Re: Comments on PREPA IRP Pre-Filing, In Re: REVIEW OF THE PUERTO RICO ELECTRIC POWER AUTHORITY INTEGRATED RESOURCE PLAN, Case No. CEPR-AP-2018-0001

Technical Comments

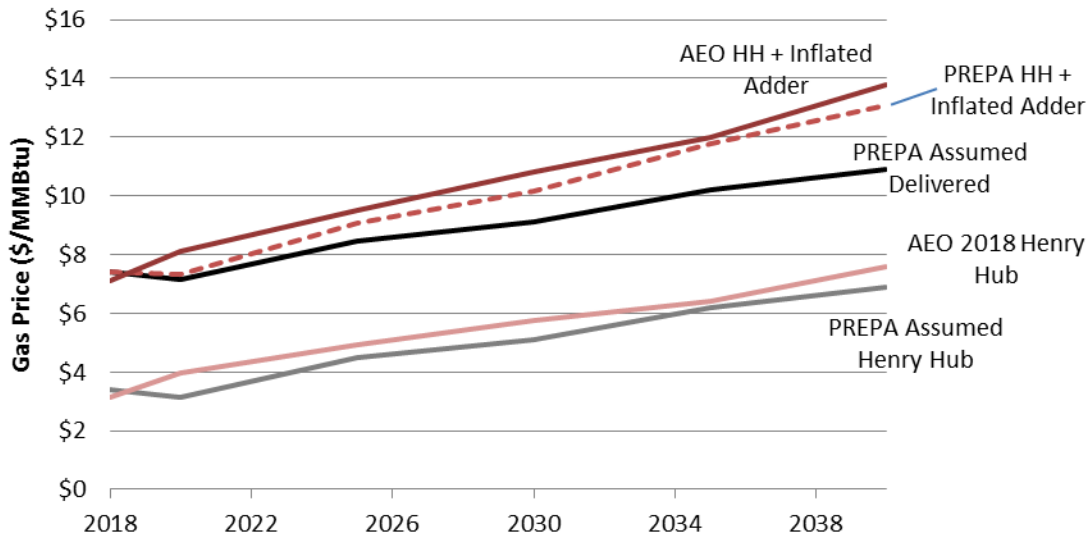
PREPA indicated that it is using approximately a \$4/MMBtu natural gas price adder to US mainland wholesale gas prices to estimate the cost of delivery to Puerto Rico (p69). During the presentation, the Commission's examiner asked if the delivery adder was held constant over time, or inflated. PREPA indicated that the adder was held at \$4/MMBtu for every year of the analysis, with no inflation, and added that [paraphrased] it was difficult to know what would happen in the future, so the price was held constant. We disagree with this treatment of the price adder. Holding the price constant in nominal dollars is an implicit assumption that the price actually drops in constant year dollars, because all other factors increase with inflation. There is no evidence that the cost of gasification or transportation could be expected to drop over the next two decades.

The outcome of this assumption is that gas is likely substantially underpriced in future years. As shown in the chart below, PREPA's assumed delivered gas price (black line) minus the \$4/MMBtu adder results in a Henry Hub price (gray) below that assumed by the Energy Information Administration's (EIA) Annual Energy Outlook (AEO) 2018 by about \$0.50/MMBtu (AEO forecast in light red). Adding the proper inflator to the LNG adder results in a gas price substantially higher than PREPA's base case (dotted red line), and even higher if the gas adder is applied to AEO's assumed baseline gas price (dark red) – on the order of \$1/MMBtu in 2020 and around \$2/MMBtu by 2030.

This error and assumption is substantial. A gas price differential of \$1/MMBtu translates to an energy cost differential of about \$6.5-8.0/MWh in 2020.

As one key example, in 2023, PREPA’s assumed price is around \$8/MMBtu, which translates to an energy cost of ~\$60/MWh (assuming 7,000 MMBtu/MWh heat rate and \$3.5/MWh variable O&M). Using a correctly inflated adder and AEO’s projections, a gas price of \$9/MMBtu would result in a gas energy cost of **\$66.5/MWh**, before capital or O&M costs for the gas port. In contrast, PREPA’s solar price in 2023 of \$1,300/kW would result in a project of roughly **\$67/MWh** (not including Puerto Rico adders or federal subsidies). This result would suggest that relatively small differentials in gas price assumptions can make tremendous impacts in model choices.

- Vet the gas price assumptions and adders, adding inflation.
- Use consistent, non-speculative basis for the forecast of prices for natural gas imports, including source region.
- Ensure that any variable costs of delivery are appropriately incorporated into the gas price forecast for individual gas delivery options.
